Project	<b>IEEE 802.16 Broadband Wireless Access Working Group</b> < <a href="http://ieee802.org/16">http://ieee802.org/16</a> >	
Title	<b>Proposals for Enhancements to IEEE 802.16 and 16a standards based on draft IEEE P802.16-2003/D0</b>	
Date Submitted	<b>2003-08-28</b>	
Source(s)	Barry Lewis, Paul Piggin and Philip Whitehead Radiant Networks PLC The Mansion, Chesterford Park Little Chesterford, Essex, CB10 1XL, UK	Voice: +44 1799 533600 Fax: +44 1799 533601 <a href="mailto:pw@radiantnetworks.co.uk">pw@radiantnetworks.co.uk</a>
Re:	This document responds to the Call for Comments on editor's draft IEEE P802.16-2003/D0, announced on 2003-08-07. It includes a set of proposed enhancements to the standard.	
Abstract	This document contains a set of proposals for enhancements to the consolidated IEEE802.16 draft, which will produce a more comprehensive multipoint system standard. No new modes that are not already described in the standards are required. Nothing is deleted from existing standards. These proposals are defined in detail and could easily be added to the standard with only a small amount of change.

# Proposals for Enhancements to IEEE 802.16 and 16a standards based on draft

**Figure 1** Detailed configuration proposal for an optional timeslot frame structure better suited to point-to-point style of operation in “directional mesh” in IEEE802.16. NB Time-of-flight compensation not shown, nor is the DL-BTG.

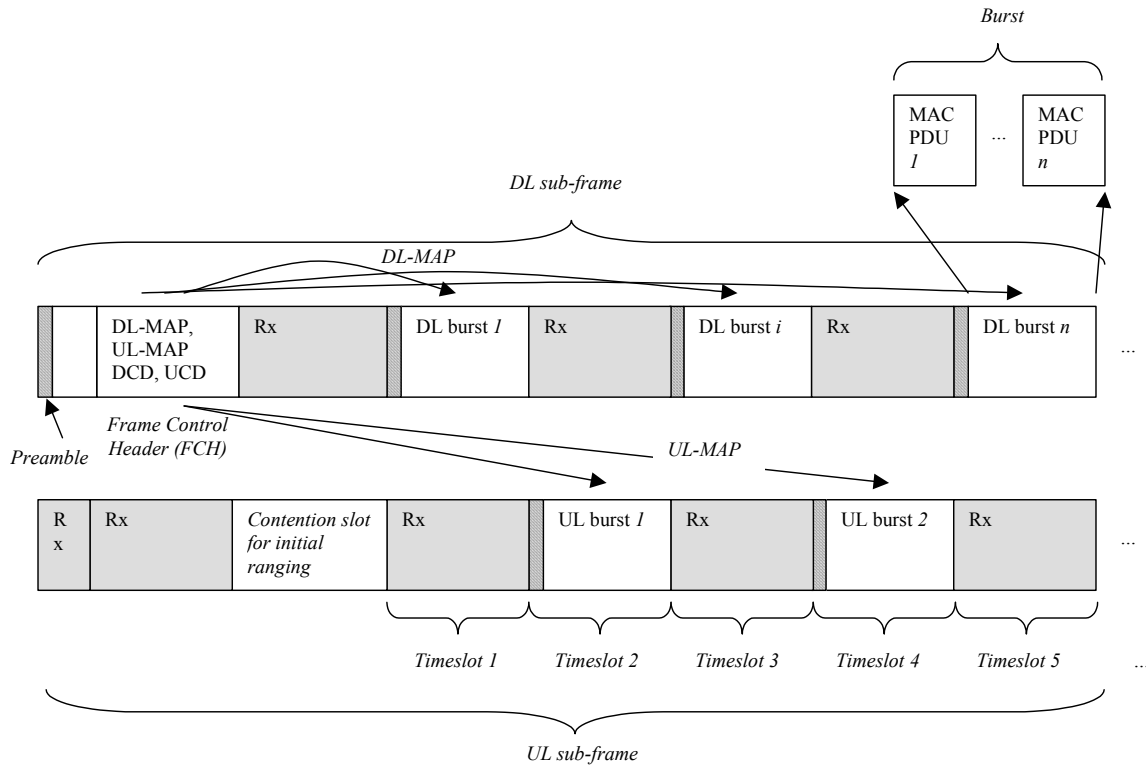
It is proposed to amend the standard to allow an FDD-like configuration to be used for point-to-point and mesh type operation. Table 1 (IEEE P802.16-2003/D0: section 1.2.4: page 2) needs to be amended accordingly to permit FDD-like operation in licence-exempt bands.

Although the standard allows for a mesh configuration and can be configured for a basic form of point-to-point operation, the burst structure for these configurations is potentially spectrally inefficient. An effective optional improvement can be described which allows freedom in defining where a DL or UL transmission occurs.

Include an optional burst structure with a TDD nature by using FDD-like half-duplex bursts, as described in IEEE C802.16d-2003/55 section 2.1. The following changes are proposed:

**Figure 3** Example configuration for station 0. NB all links shown are duplex links, the arrowheads show BS to SS link termination orientation.

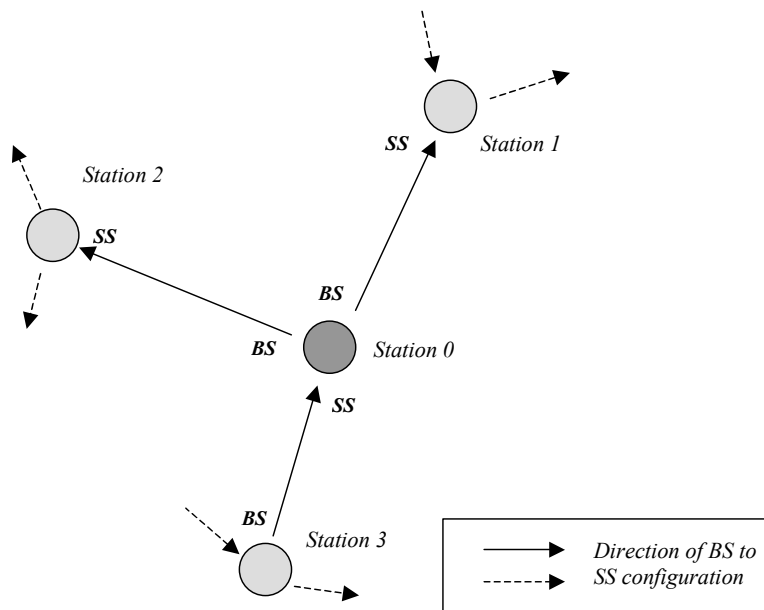
The solution is presented with an example configuration. This is shown in Figure 3, with frame configuration given in Figure 4. The solution provides station configuration and synchronization using a fixed reference e.g. GPS. The *station hold-off* respects the constraints of H-FDD and permits a preamble to be transmitted on every link at the start of the frame but not at the same time. This is part of a so-called *slotted preamble* section of the frame. The *frame control header* or FCH follows. It is likely that there will be a gap following the *slotted preamble* section before the start of the FCH (as shown in Figure 4). To achieve this gap (which is not expected as the FCH is expected straight after the frame preamble) a similar method used for the UL, were the *start alloc time* is used, is proposed. The UL-MAP is defined in Table 17 (IEEE P802.16-2003/D0: page 64) and provides an indication of the start of the UL allocation in the form of the *start alloc time*. It is intended to include this mechanism in the DL-MAP in Table 15 (IEEE P802.16-2003/D0: page 62). This parameter will be a 32bit representation of the start of the FCH in mini-slots (similar to the UL version), and will be added to the DL-MAP. The modified DL-MAP MAC message is shown in Figure 2.

**Figure 5** Configuration of MAC messages used in power control.

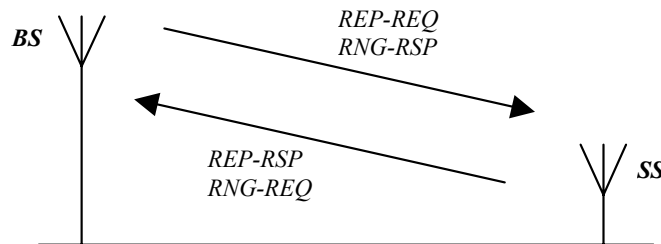
The IEEE802.16 standard should be extended to allow REP-REQ MAC messages to be sent by both the BS and SS, in addition both the BS and SS should be able to send REP-RSP MAC messages and be mandated to provide the necessary measurements. A similar proposal holds for the case that the RNG-REQ and RNG-RSP MAC message pair used for power control.

- Permit the SS to send REP-REQ MAC messages for power control measurement defined in section 6.4.2.3.33 (IEEE P802.16-2003/D0: page 93),
- Permit the BS to send REP-RSP MAC messages for power control measurement defined in section 6.4.2.3.33 (IEEE P802.16-2003/D0: page 93),
